**Bulletin 2 of 2000: Change to Product.**  
**3 Aug, 2000** (revision of Bulletin 1 of 1999)

**Subject: Change of Yoke**

**Products Affected: Yokes for the SuperLite 17 A/B & MK 21 Helmets**

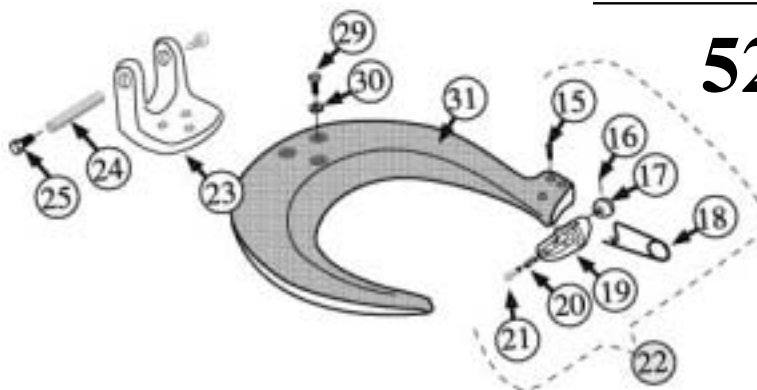
DSI is replacing the existing fiberglass yoke, DSI Part Number 520-060, with a new yoke, **DSI Part Number 520-117** (no price change). The new yoke is made of a durable black polyurethane, molded around a stainless steel core, and is slightly heavier than the fiberglass. This yoke will become standard equipment on all SuperLite 17 A/B & MK 21 helmets produced as of June 15, 1999.

The new yoke is **fully retrofittable** with the fiberglass unit it replaces and is readily retrofittable to all SL-17 A/B helmets. The only difference is that the three stainless washers, (DSI Part Number 530-530 - location number 30 on the exploded view), used on the fiberglass yoke hinge installation are **NOT USED** on the polyurethane yoke hinge installation. Discard these washers responsibly as they pose a choking hazard to small children and pets.

**New Part Number**

**520-117**

**Old Part Number**

**520-060**
